VILLAGE OF LOMBARD
INTER-DEPARTMENTAL REVIEW GROUP REPORT

ZBA 10-10; 460 S. Main Street, Lombard (Babcock's Grove) Cemetery: The petitioner requests that the Village approve the following actions for the subject property located within the R2 Single-Family Residence District:

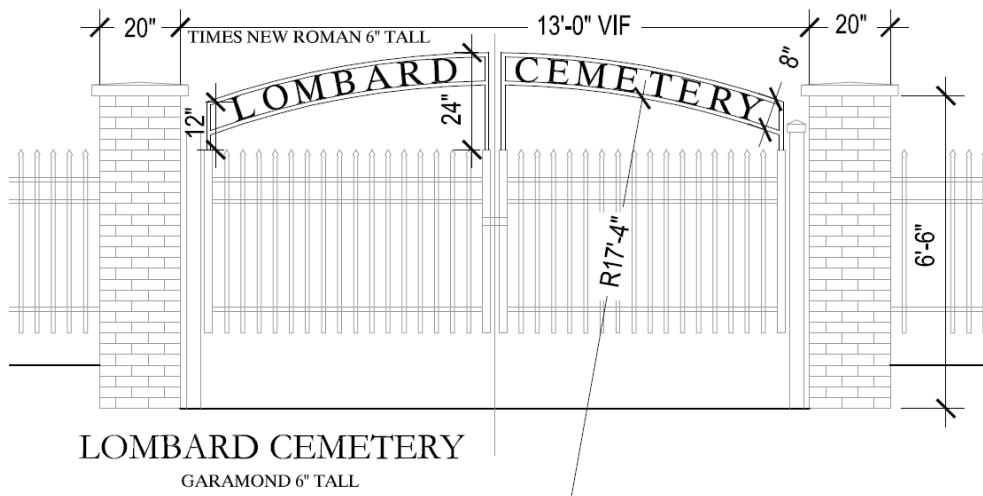
The proposed arch is affiliated with a public institution and contains text; therefore, it is considered an 'Institutional Sign'. According to the Sign Ordinance, freestanding institutional signs shall not exceed six (6) feet in height. The proposed arch is 7.4 feet above grade, thus requiring a height variation. The proposed arch is twenty-six (26) feet in area. Institutional Signs shall not exceed

thirty-two square feet; therefore, the signage portion of the arch is within the size parameters. The proposed arch meets all other Sign Ordinance requirements.

The subject property is located in the R2 – Single Family District. The proposed arch is to be located in the front yard of the subject property. According to the Zoning Ordinance, fences located in the front yard of a residential district shall not exceed four (4) feet in height. As previously mentioned the arch will be supported by posts, which extend up from the fence/gate. Therefore, staff is considering the arch to also be an extension of the existing fence. The proposed arch is 7.4 feet above grade, thus also requiring a fence height variation

1. The arch shall be developed in substantial conformance with the elevation plan prepared by T.R. Knapp Architects dated August 1, 2010.
2. The height of the arched sign over the fence shall not exceed 7.4 feet above grade.
